_____*Revision A*

This document details hardware fixes done on the MPOS-SDT2 EV-KIT revision A.

2) BATTERY CHARGE LED (D9)

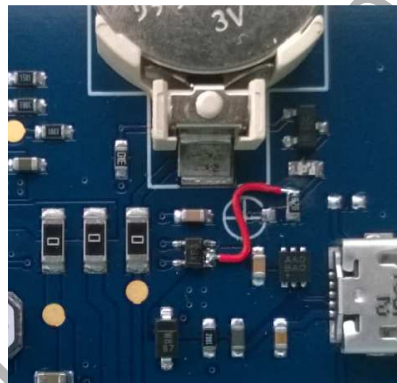
The LED D9 lights when the secondary battery charge is completed. This indicator should normally be enabled only while charging, when V_VBUS is present. In the schematic the LED D9 is powered by V_SBAT_VDD instead of V_VBUS. Consequently, the indicator is enabled even if there is no external power source connected to then it could draw current from the secondary battery.

R81 has been connected to V_VBUS and is value updated accordingly.

3) SMARTCARD CARD DETECTION POLARITY

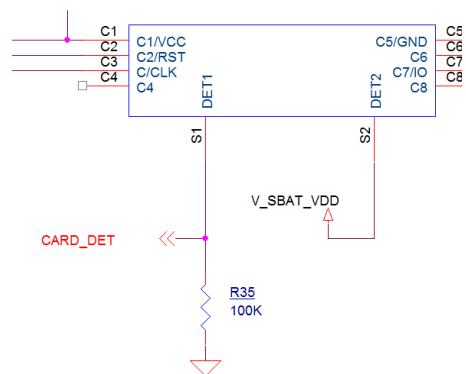
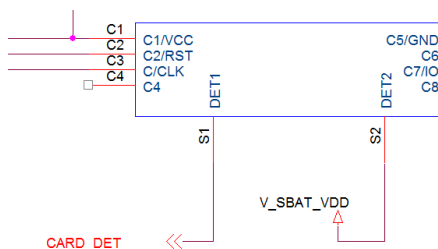
Even if the MAX32550's card detection polarity can be selected by software, it is recommended to use the high level with a version up to A3. This is to avoid missing the first card insertion event. Because the MAX32550's card detection I/O includes a weak pull-up an external pull down is needed with normal open detection switch.

A pull down resistor has been added.
